PSI DWG # 1049-8-526 ^{DEC 19 1996}

REV. B
A
DWG. NO. 103853

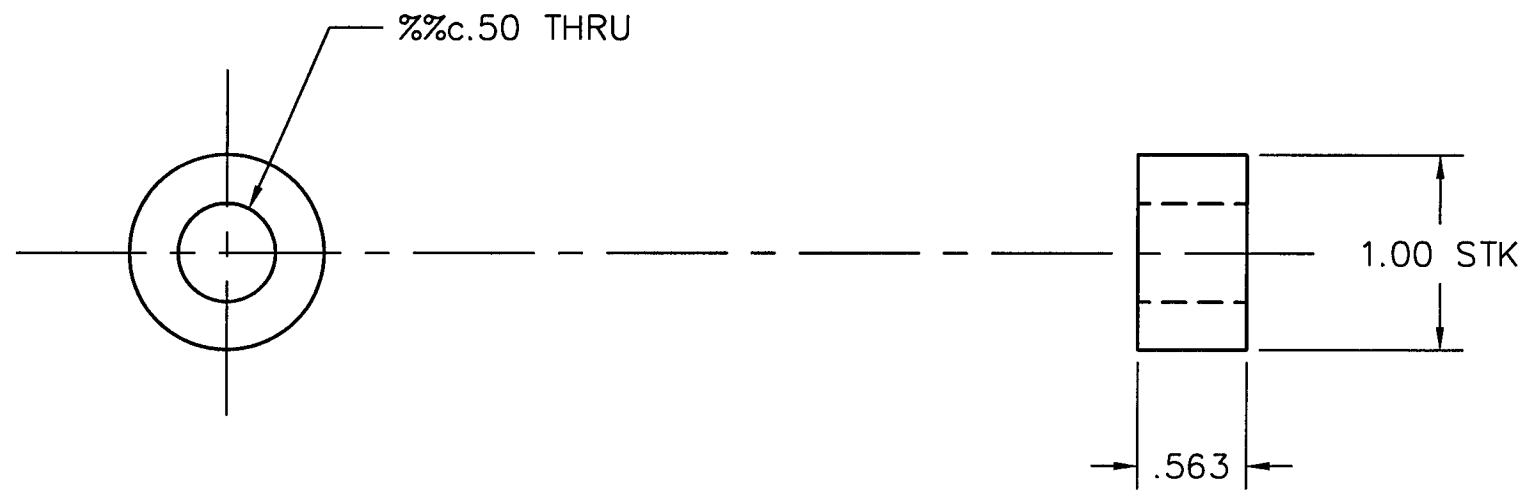
REVISIONS			
REV.	DESCRIPTION	APPROVED	DATE
A	RELEASED	AJL	11-9-96
B	Ø.50 THRU WAS Ø.38 THRU	AJL	11-18-96
